Access Compliance Report Public Rights-of-Way (Curb Ramps)

Main Street: N/A Cross Street: RED_HILL_AVE Location: N

ADA ID: RPRK220107120151 Ramp Type: Type 7 - Directional 2 Initial Pass/Fail: Fail Overall Compliance: No Severity Score: 15

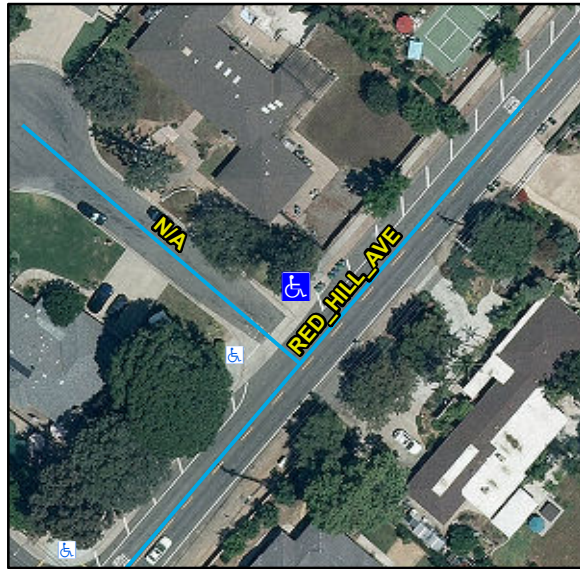
Compliance	Description	Data	Compliance	Description	Data
N/A	Ramp Length (in)	70	N/A	Flare Type LT	
Yes	Ramp Width (in)	75			N/A
No	Ramp Run Slope (%)	9.9	N/A	Flare Slope LT (%)	N/A
Yes	Ramp Cross Slope (%)	0.4	N/A	Flare Traversable LT	N/A
N/A	Grade Break	N/A	N/A	Flare Type RT	
N/A	Grade Break Slope (%)	N/A			N/A
N/A	Grade Break Cross Slope (%)	N/A	N/A	Flare Slope RT (%)	N/A
	Addl Para Ramp Left?	No	N/A	Flare Traversable RT	N/A
	Addl Para Ramp Right?	No	N/A	DWS Provided	N/A
N/A	Landing Present	N/A	N/A	DWS Contrast	N/A
N/A	Landing Length (in)	N/A	N/A	DWS Length (in)	N/A
N/A	Landing Width (in)	N/A	N/A	DWS Full Width	N/A
N/A	Landing Run Slope (%)	N/A		DWS Offset Type	N/A
N/A	Landing Cross Slope (%)	N/A	N/A	DWS Left Offset (in)	N/A
N/A	Landing Movement Obstructed?	N/A	N/A	DWS Right Offset (in)	N/A
	Landing Movement Type	N/A			
N/A	Landing Shared	N/A			
N/A	Marked Crosswalk 1	No	N/A	Clear Space	Yes
	Crossing 1 Direction	SW	N/A	Clear Space To Crosswalk (in)	N/A

Marked Crosswalk 1 Width (in)	N/A			
N/A	Ramp Inside Crosswalk 1	N/A			
	Crossing 1 Slope (%)	2.2			
	Crossing 1 Cross Slope (%)	0.7			
N/A	Gutter Ponding	N/A	N/A	Curb Slope	4.2
No	Gutter Lip Height (in)	0.25		Road Run Slope (%)	0.6
N/A	Gutter Run Slope (%)	N/A		Road Cross Slope (%)	0.8
N/A	Gutter Cross Slope (%)	N/A		Parallel Ramp Side	Left
Yes	Overall Surface Condition	Acceptable	No	Perp Joint Present	No
	Cross Gutter Present?	Yes		Spandrel Present?	Yes
	Replace Cross Gutter?	No		Replace Spandrel?	No

Remove & Replace Curb Ramp With Two New Directional Ramps or Equivalent. Grind Gutter Lip.

R204.3, R304.2.2, R302.7.2, STD 1115
